WATERLOO METRO QUARTER BUILDING 3&4

SSD-10437 - RESPONSE TO SUBMISSIONS
SUPPLEMENTARY DESIGN REPORT

PREPARED FOR WATERLOO DEVELOPER PTY LTD
DOCUMENT NO. WMQ-BLD34-BSA-AR-RPT-DA210

Revision A

Alternative Strategy B

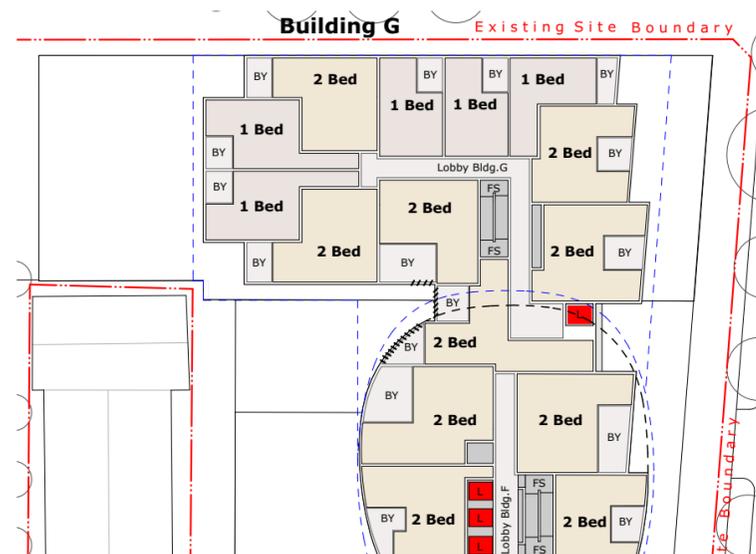
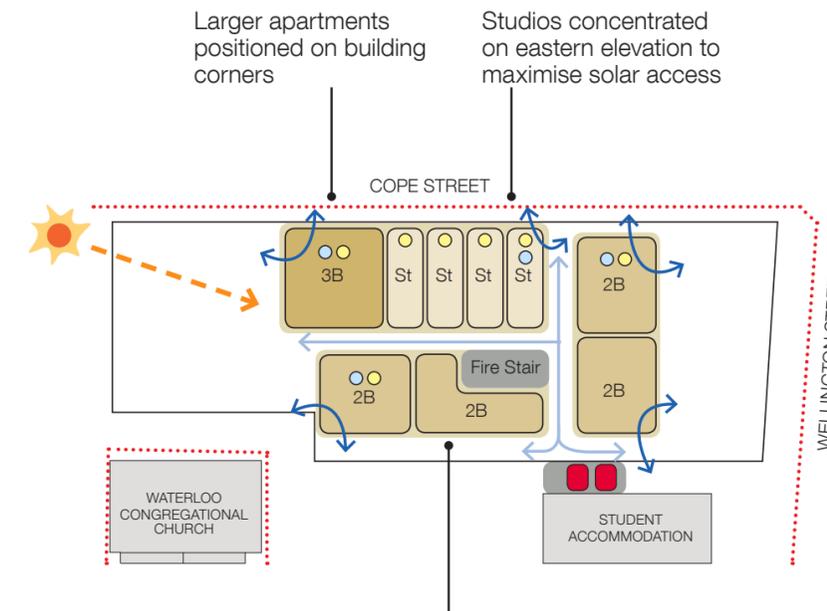
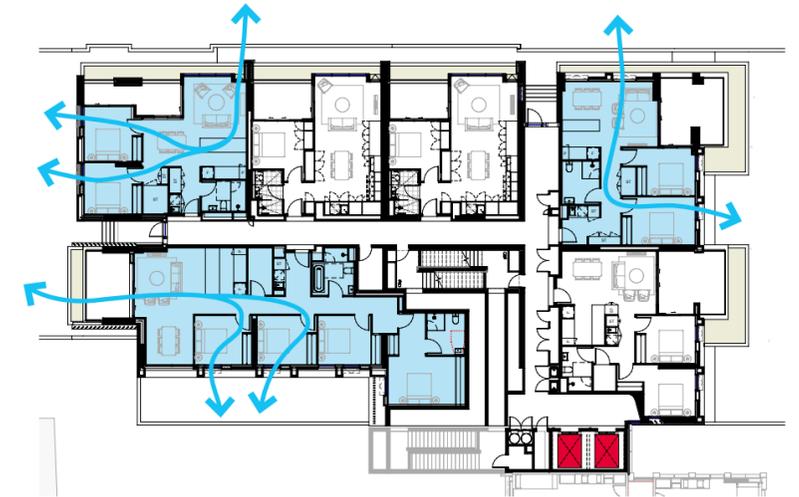
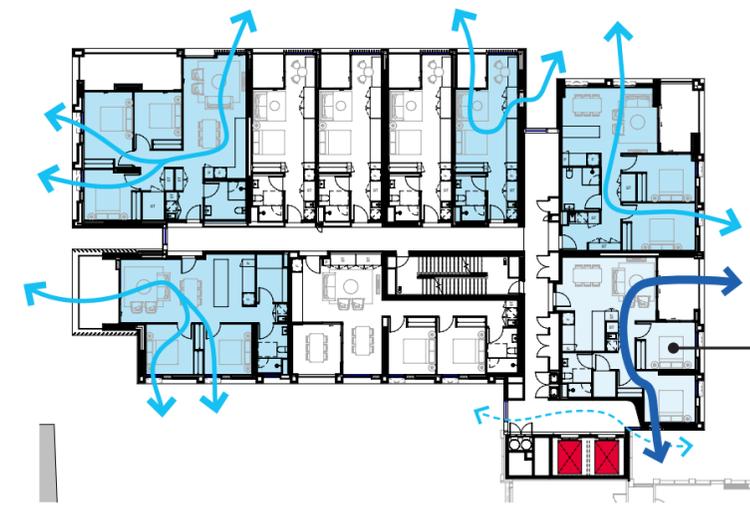
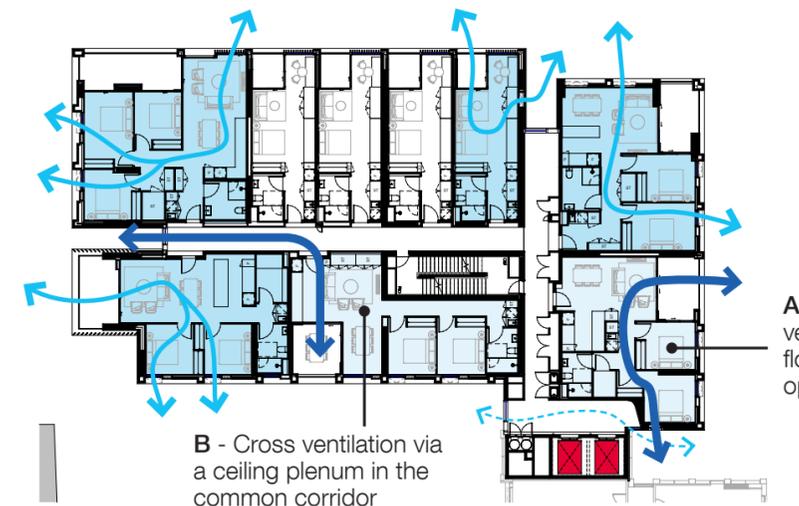
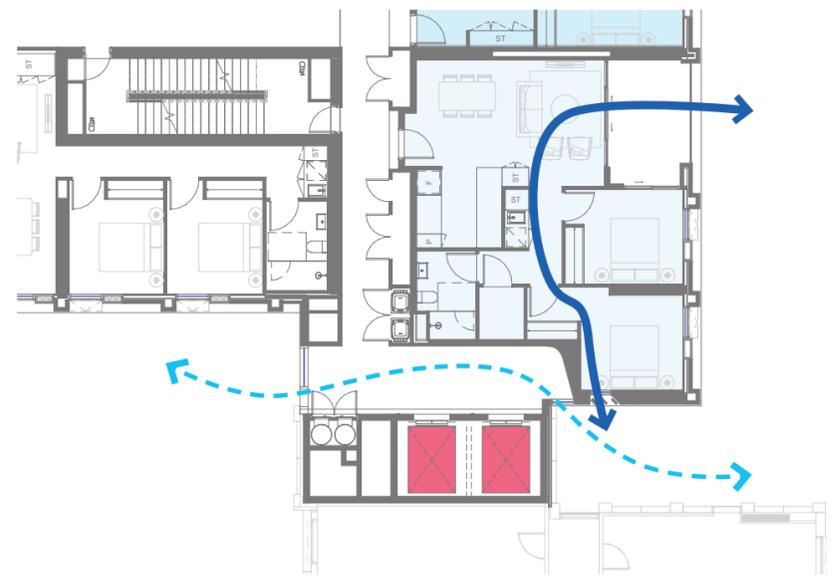
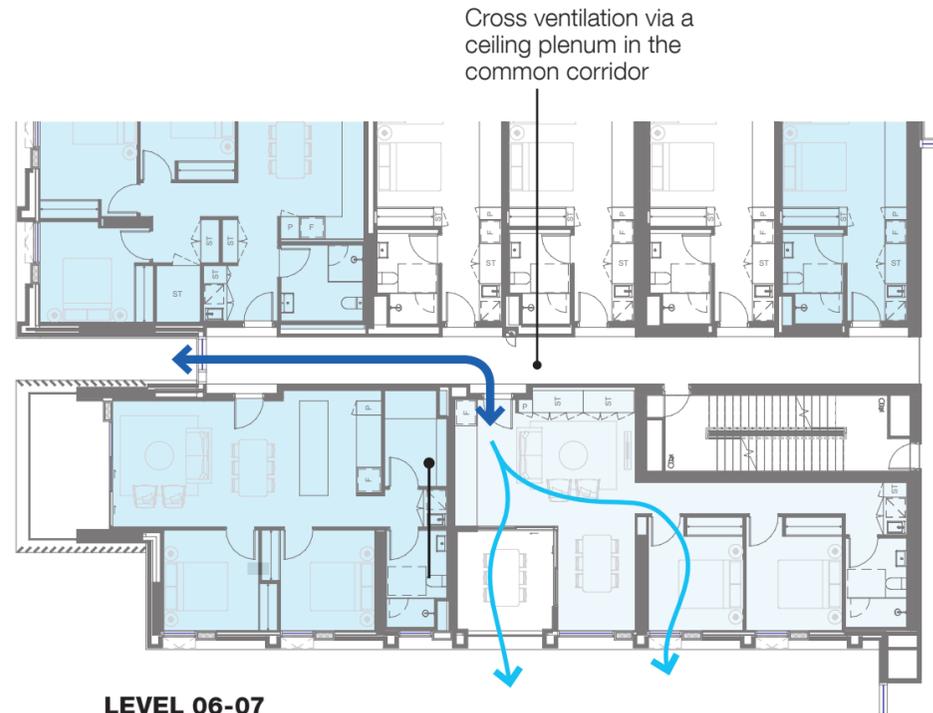
The application erroneously claims that 60% of apartments are designed to achieve natural cross ventilation, however only 34% of apartments meet the definition of naturally cross ventilated. For example:

- (a) Plenums must not be used to claim natural cross ventilation as they do not provide equal sized outlets for pressure-based airflows.
- (b) Corner apartments that do not have opposite openings of equal size and do not provide a logical flow path of air should not be counted.
- (c) Natural ventilation paths should not cross common circulation spaces.

Furthermore, 21 apartments are identified as being noise affected and are designed with acoustic ventilators to achieve natural ventilation and acoustic privacy to achieve Objectives 3B-2, 4J-1 and 4J-2 of the ADG. As a result, only 10% of apartments achieve natural cross ventilation.

The proposed design has 33 of 70 apartments (47.1%) that are conventionally cross ventilated in accordance with the ADG, whilst an additional 13% achieve appropriate ventilation through alternative measures as supported by the Design Guidance under the ADG where sites are otherwise constrained, as is the case here. Our response includes an analysis of the envelope constraints that have limited the ability to achieve compliance, as well as our design responses to maximise cross ventilation amenity through alternative design strategies.

A total of 33 (47.1%) dwellings are naturally cross ventilated by virtue of windows facing in more than one orientation. Due to the constraints of the envelope and the prescribed apartment mix, achieving compliance through conventional cross ventilation is limited. To achieve cross ventilation amenity elsewhere, we have proposed the following alternative strategies:

B - Two apartments on Levels 06 & 07 will be connected to the northern slot via a plenum in the ceiling of the common corridor to provide natural cross ventilation. In these instances, the distance between openings does not exceed 18m.

The south west 2 bedroom apartment takes advantage of the cross ventilation flow path through the open lift lobby to create a pressure differential. This pressure differential draws air through the apartment via openings on opposing sides.

Two apartments on Levels 06 & 07 will be connected to the northern slot via a plenum in the ceiling of the common corridor to provide natural cross ventilation. In these instances, the distance between openings does not exceed 18m.

Plan Detail of Acoustic Ventilator (Drawing by Stantec)

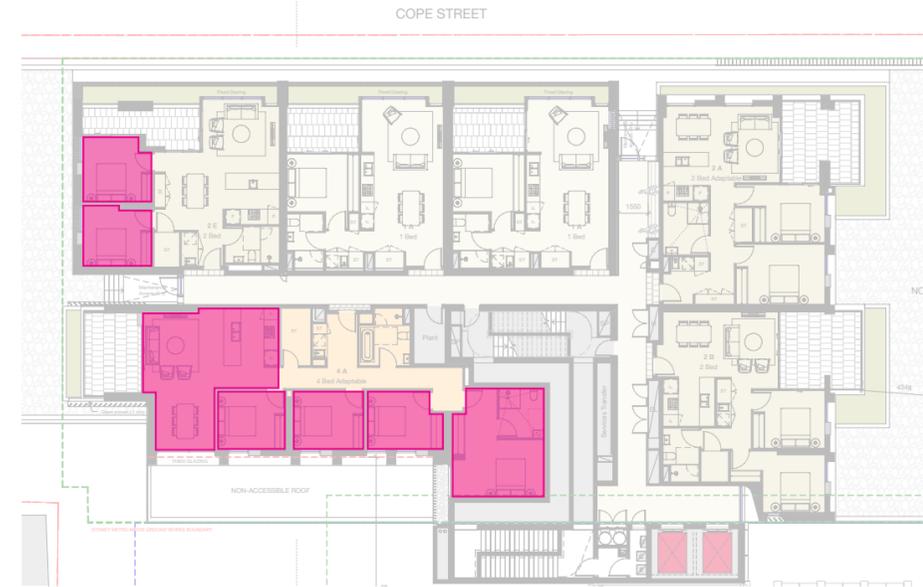
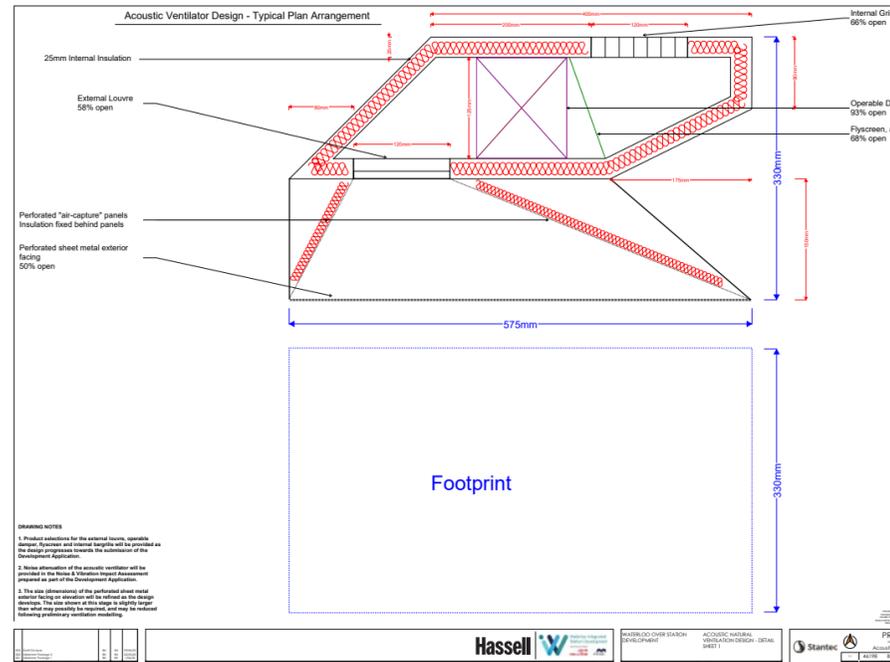
29-34 Objective 3B-1 of the ADG requires all habitable rooms to be naturally ventilated. Objective 4J-1 requires development in noisy or hostile environments to minimise the impact of external noise and pollution through the careful siting and layout of buildings. The applicant has identified apartments within the central and southern precincts as being noise affected and requiring acoustically attenuated natural (non-mechanical) ventilation systems to meet these objectives. (City of Sydney)

Acoustic ventilators are proposed to all of the noise affected spaces to provide acoustically attenuated natural ventilation without having to open the windows. The acoustic ventilators have been integrated into the building facade design, and are expressed on the facade as bronze coloured perforated aluminium panels.

CFD modelling has been undertaken by Stantec, with a physical prototype proposed to be fabricated for further testing. For further detail, refer to the technical response prepared by Stantec.

INDICATIVE VIEW OF THE EAST ELEVATION

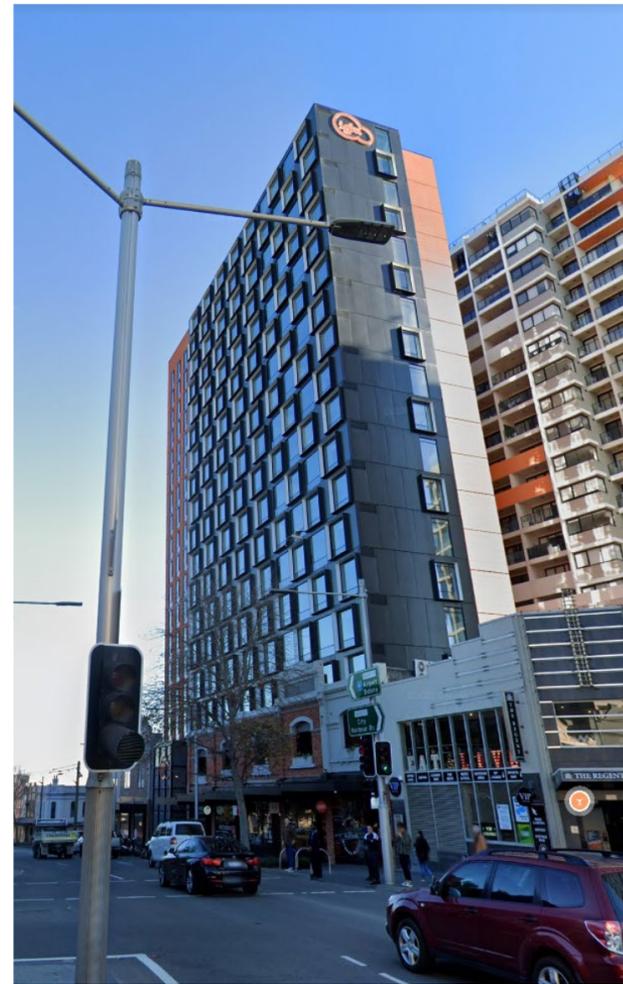
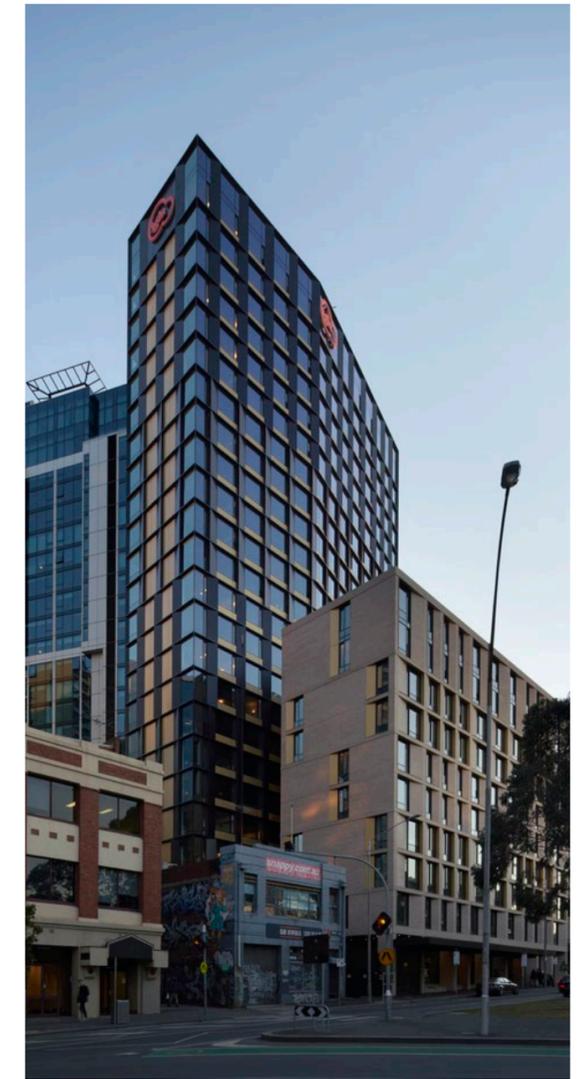
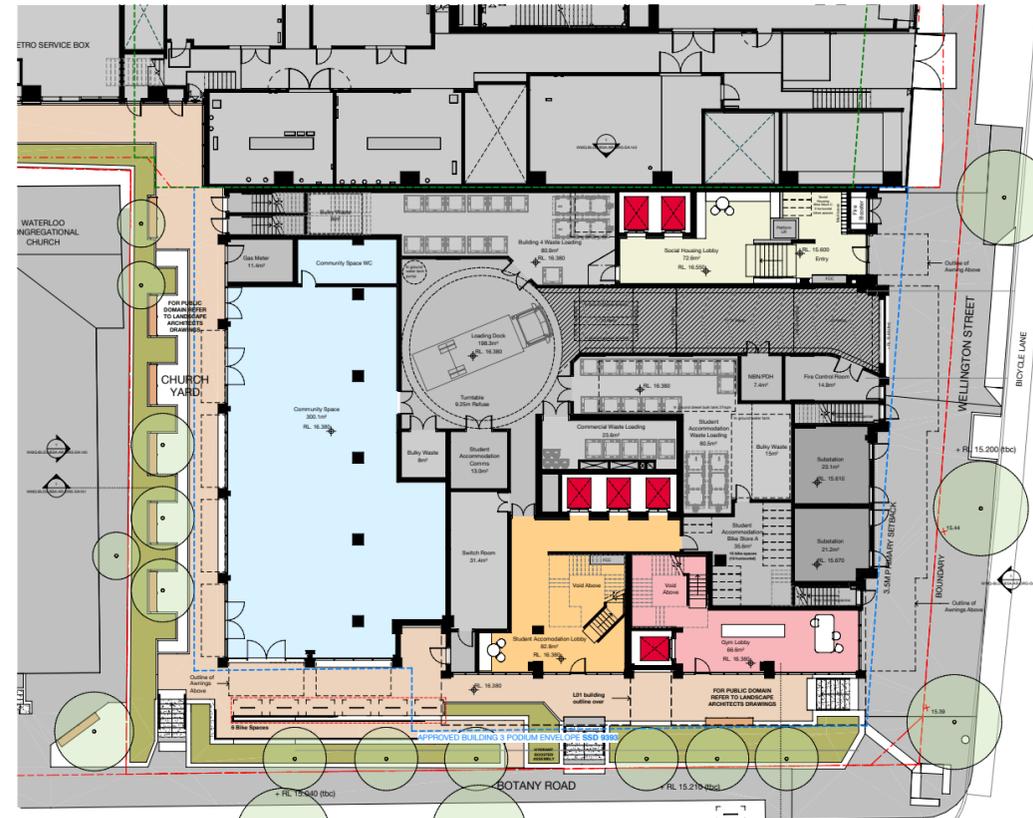
76. Top of building signs are proposed to the commercial and student housing buildings. The proposal is inconsistent with the Schedule 1 Assessment Criteria under State Environmental Planning Policy 64 – Advertising and Signage as top of building signs are prohibited within this location in accordance with sections 3.16.5.2 and 3.16.12.15 of the SDCP. Furthermore, the signs are not accommodated under the Waterloo Metro Quarter Design and Amenity Guidelines. (City of Sydney)

Top of building signage is proposed in two locations on the tower; on Level 23 of the eastern building end facade to provide signage visible from Wellington Street, and on Level 22 of the northern building end facade to provide signage visible from Botany Road and Cope Street Plaza.

/ not illuminated

/ integrated with overall building design

/ integrated with facade design to ensure concealed fixings
